# TOWN OF GUILDERLAND

## MEMORANDUM

SUBJ: **Planning Board Site Plan Report to the Zoning Board of Appeals  
163,000 Square Feet Retail Facility (Costco) - Crossgates Releaseco, LLC**

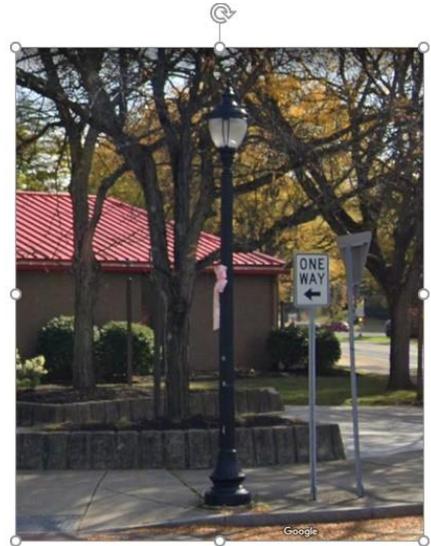
In furtherance of those considerations, the Planning Board has requested, and the Applicant has provided to the Planning Board certain updated plans and information which are being forwarded to the ZBA with this site plan review report. These updates to the application materials include:

- a plan showing the reorientation of the building to face Western Avenue and associated additional parking, circulation, pedestrian, landscaping, and access site improvements submitted to the Town on March 10, 2023

- a plan showing the relocation and reconfiguration of the western access drive to Crossgates Mall Road and a signalized Gabriel Terrace intersection with Crossgates Mall Road

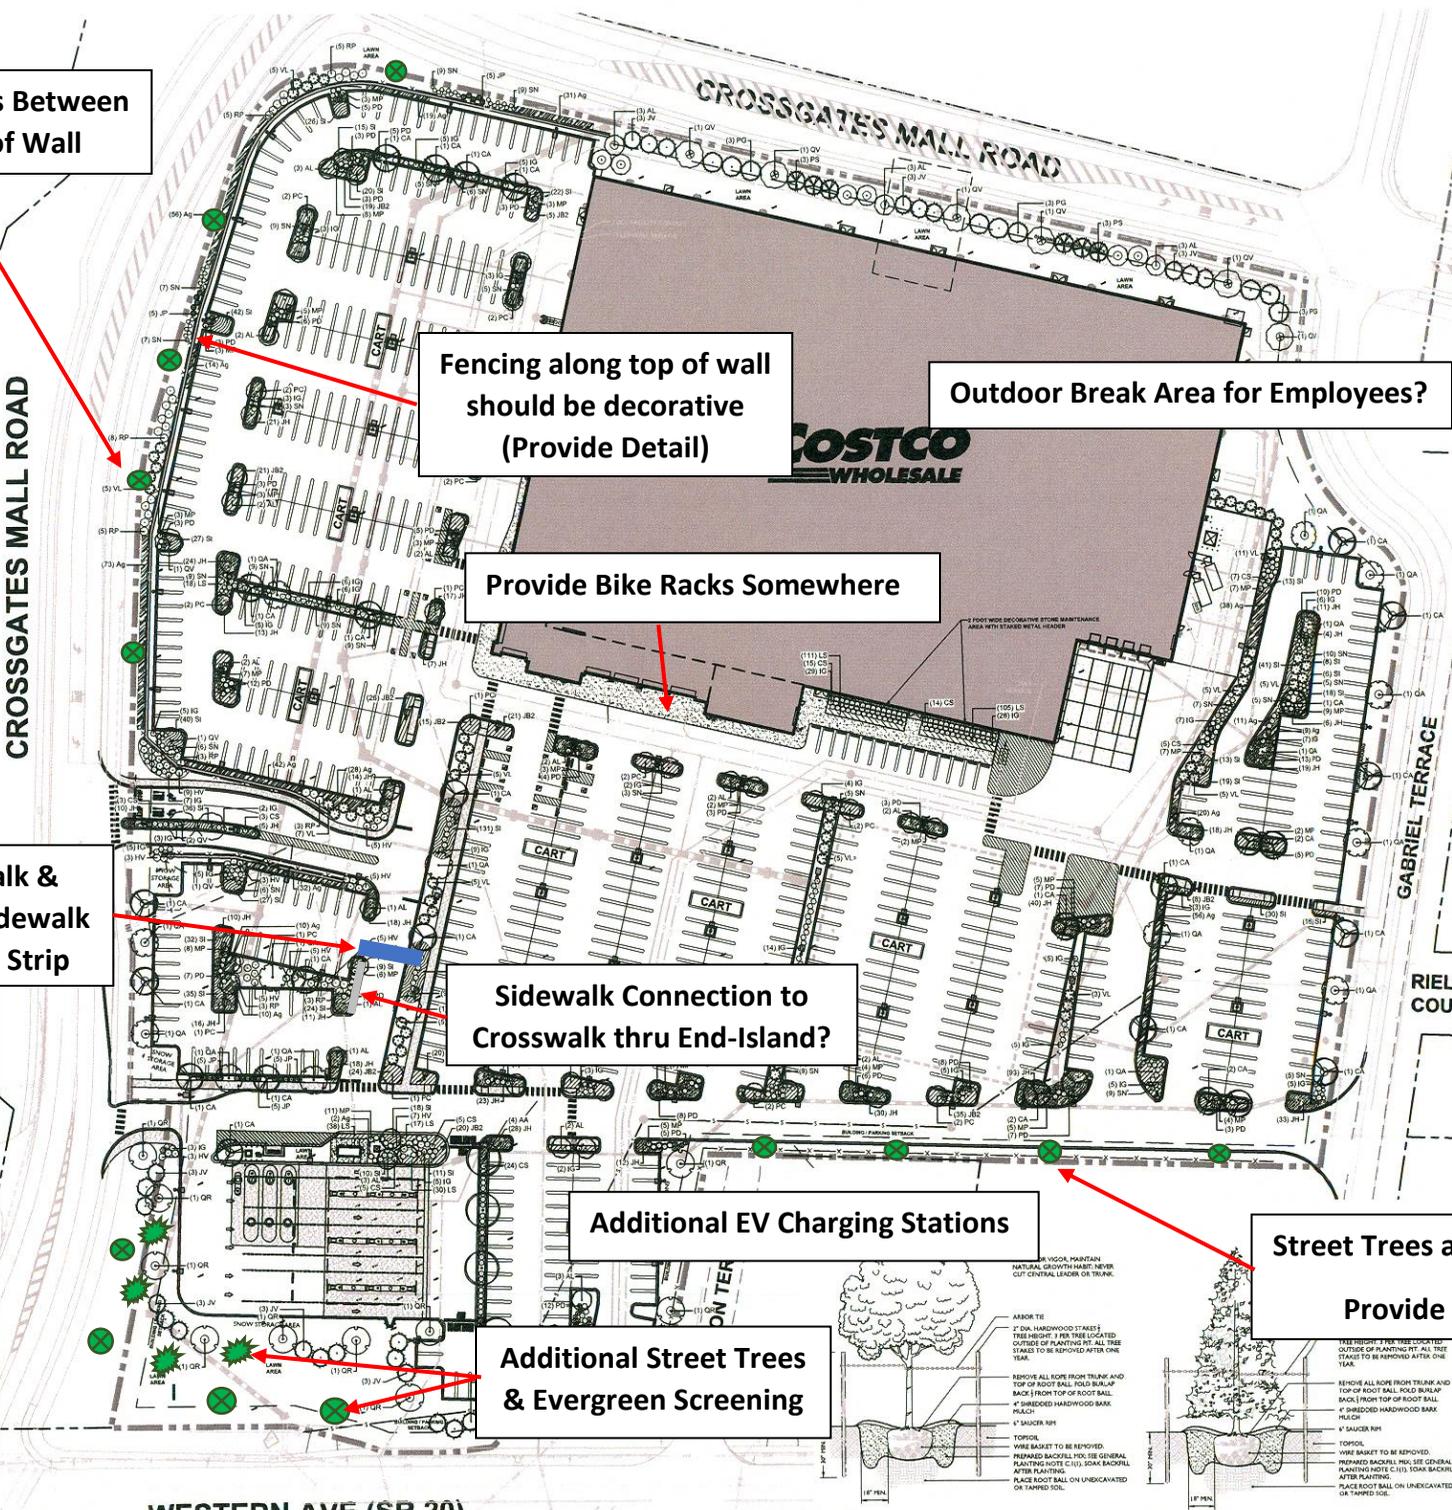
Add Street Trees Between Path & Top of Wall

Fencing along top of wall should be decorative (Provide Detail)

Outdoor Break Area for Employees?

Provide Bike Racks Somewhere

Replace White Pine with Pitch Pine Per Commission Comments

Install Crosswalk & Connection to Sidewalk thru Landscape Strip

Sidewalk Connection to Crosswalk thru End-Island?

Can We Add Highbush/Lowbush Blueberries, New Jersey Tea?

Can we add some pollinators such as Butterfly Milkweed?

Additional EV Charging Stations

Street Trees along Access Drive Provide Fence Detail

Additional Street Trees & Evergreen Screening
